DC POWER LINE FILTER

DRAWN: Ku		DATED: 11/04/2023		COMPANY: RFNet Technologies Pte Ltd	
CHECKED: Nelson		DATED: 31/07/2023		TITLE: DC Power Supply	
QUALITY CONTROL:		DATED:		CODE:	SIZE:
RELEASED:		DATED:		D	SCH-1096
SCALE:		SHEET: 3 of 8		REV:	00

5V provide by external power supply
Current Sensing

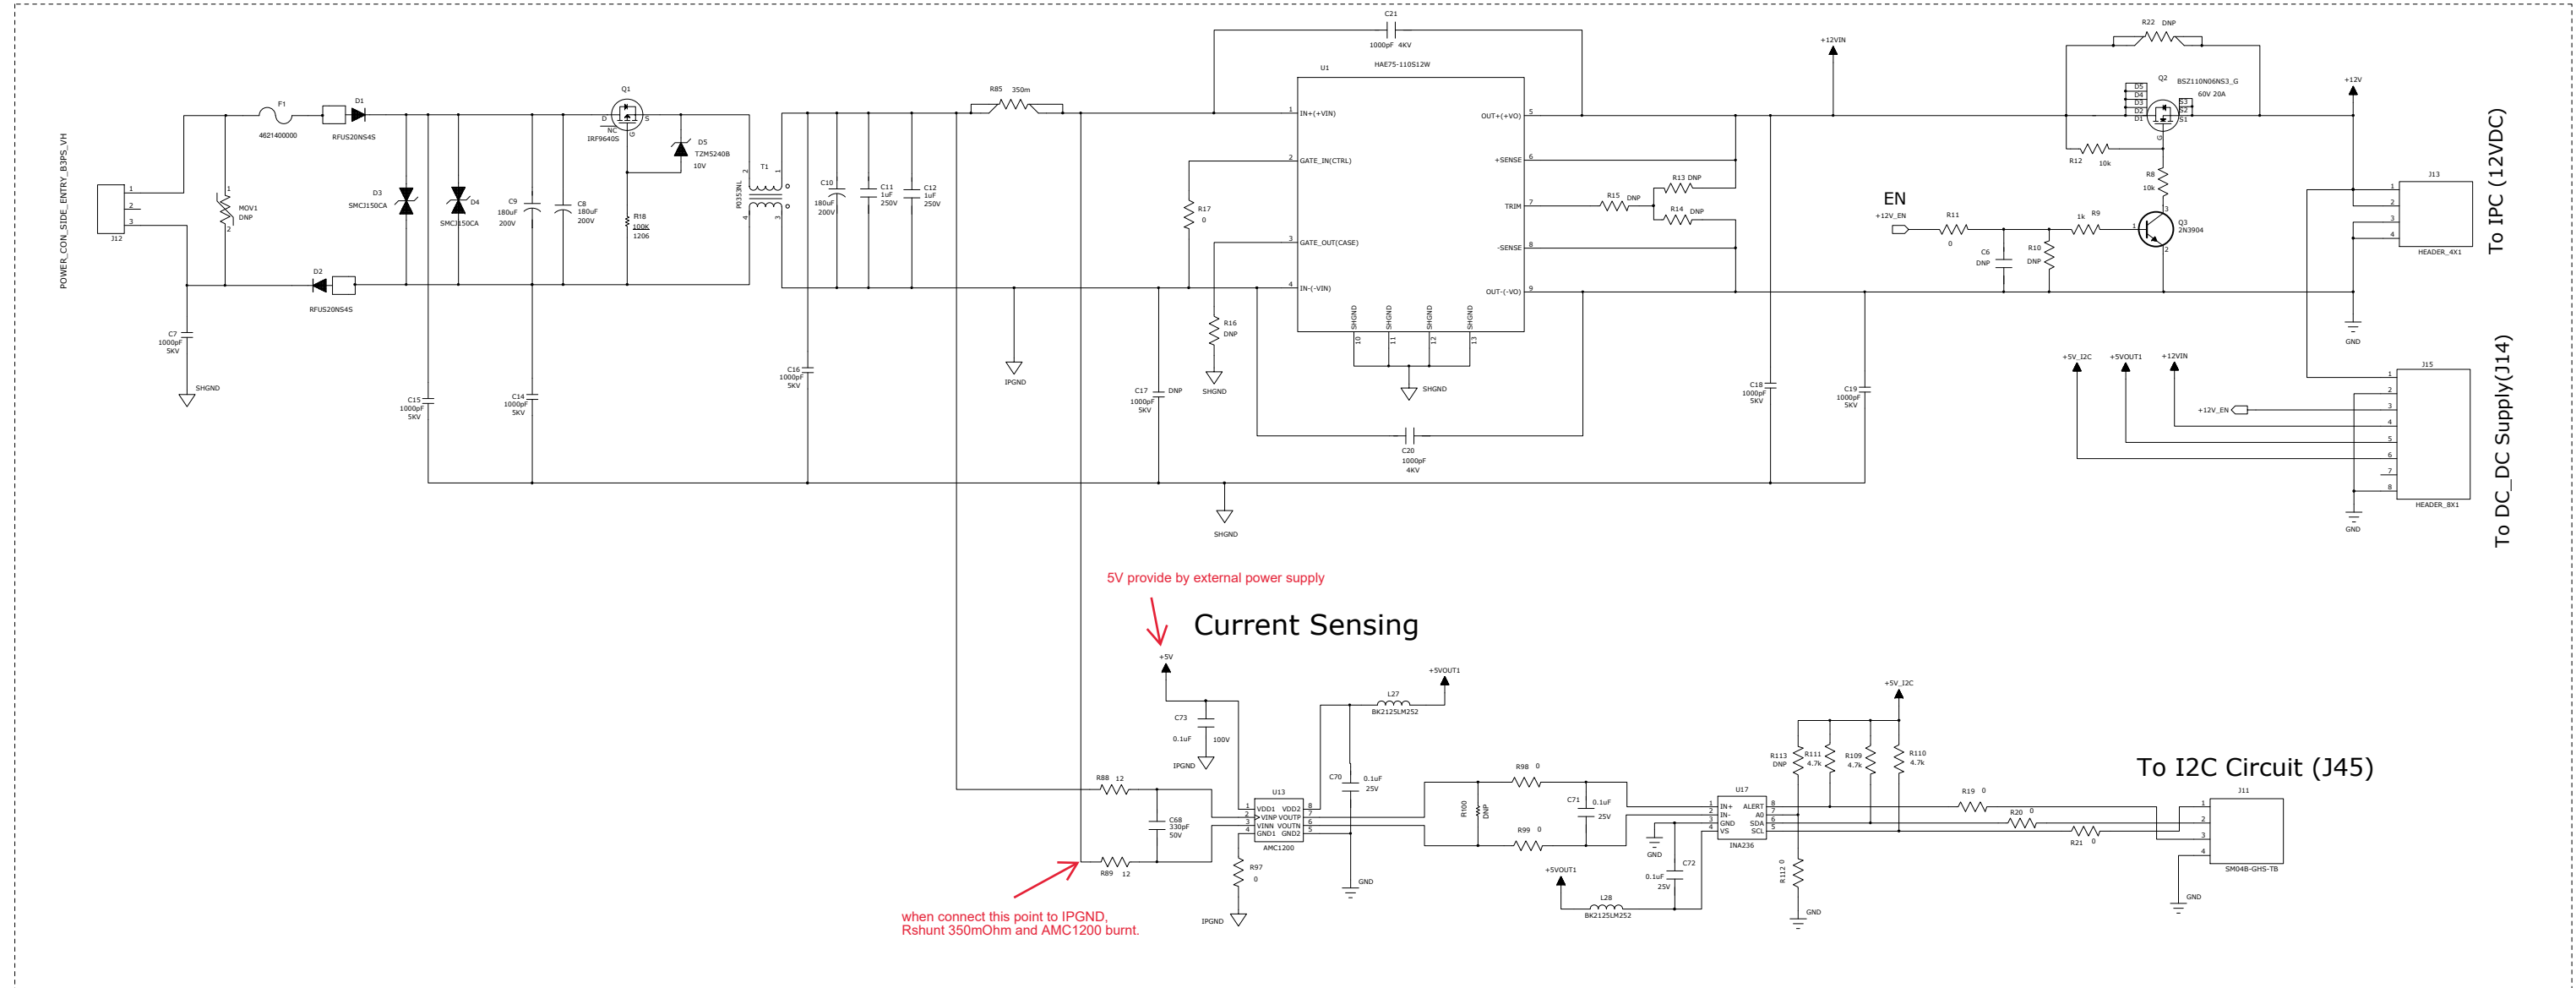
when connect this point to IPGND, Rshunt 350mOhm and AMC1200 burnt.
